REVIEW OF GROUND-WATER MONITORING AT SANDIA NATIONAL LABORATORIES'S MIXED WASTE LANDFILL

by William P. Moats and Lee Winn
AIP/DOE Oversight Group
Hazardous & Radioactive Materials Bureau
New Mexico Environment Department
March 1993

Figure 1. Map of Mixed Waste Landfill showing monitor wells, trenches, and waste pits (modified from Anonymous, 1991).

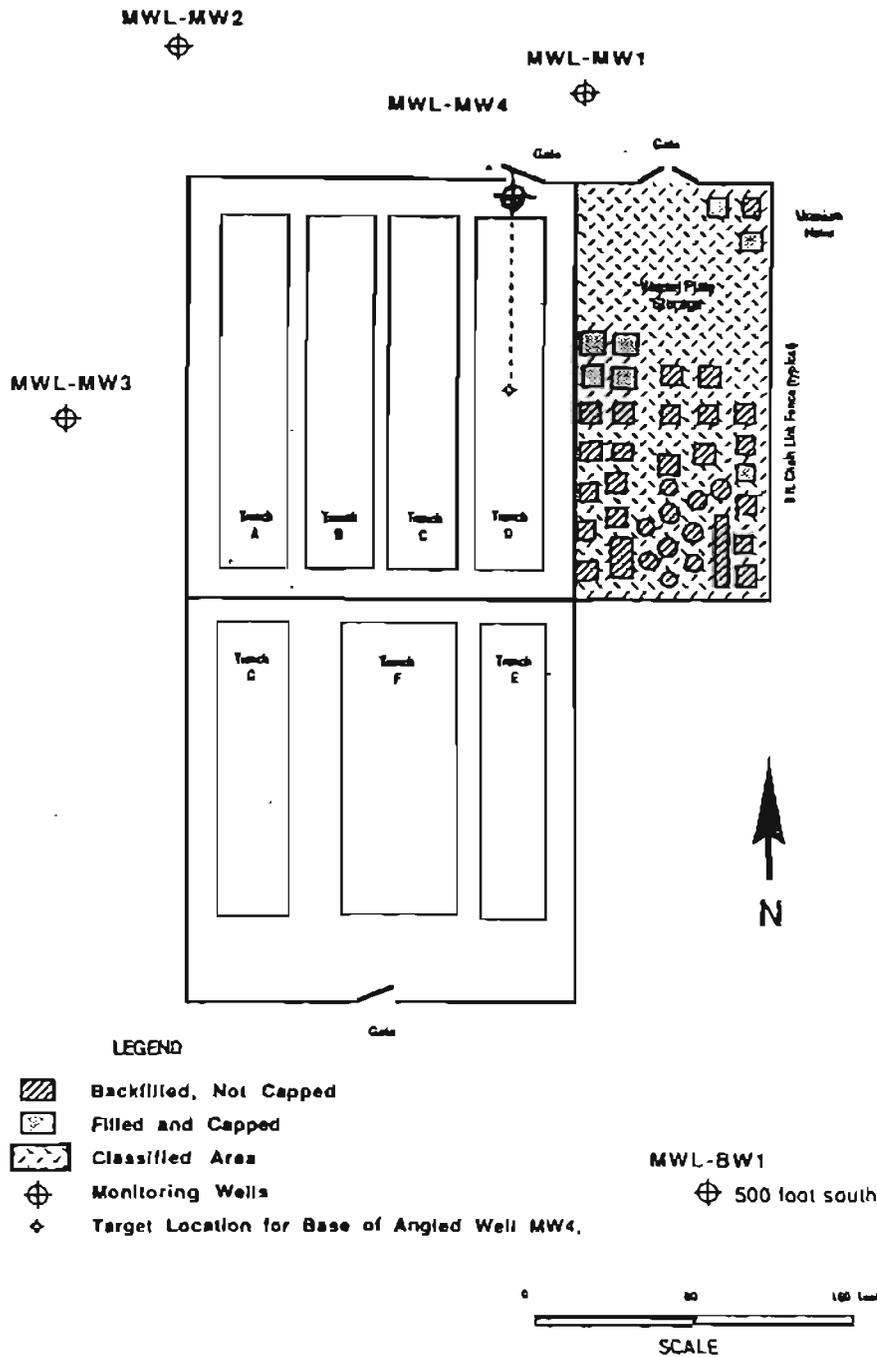
A total of five ground-water monitor wells have been installed at the MWL (Figure 1). A fairly detailed report describing the installations of monitor wells MWL-MW2, MWL-MW3, and MWL-BW1 was prepared for SNLA by Ecology and Environment, Incorporated (Anonymous, 1989). This same report also describes the installation of MWL-MW1, which was drilled similarly and at about the same time period as the 1988 CWL monitor wells. The first well, MWL-MW1, was installed at the MWL in 1988 by air-rotary casing-driven drilling methods. Monitor wells MWL-MW2, MWL-MW3, and MWL-BW1 were completed by September 1989 using mud-rotary drilling (Anonymous, 1989). In general, installation of the latter three wells consisted of drilling exploratory pilot holes for soil sampling and geophysical logging, followed by reaming of the pilot holes to facilitate construction of the wells.

known with reasonable certainty. Data suggest that the water table may be mounded near the northeast boundary of the site. Additional wells installed at the MWL at greater distances from the facility than the existing wells would better define the horizontal gradient and direction of ground-water flow.

1. Monitor well MWL-MW4 will not prevent unavoidable random errors associated with Depth-to-Water (DTW) measurements. Although DTW averages about 460 ft, wells MWL-MW1, MWL-MW2, and MWL-BW1 have static water levels which typically differ by only 0.1 foot or less. Even with well casing deviation surveys, errors in DTW measurements will likely exceed the differences in static water levels between monitor wells. Thus, it is doubtful that the horizontal direction and gradient of ground-water flow can be reliably determined using the existing monitor well network, even with the addition of MWL-MW4. Additional monitor wells will have to be installed at the MWL which are located at greater distances from the landfill to adequately resolve this problem.
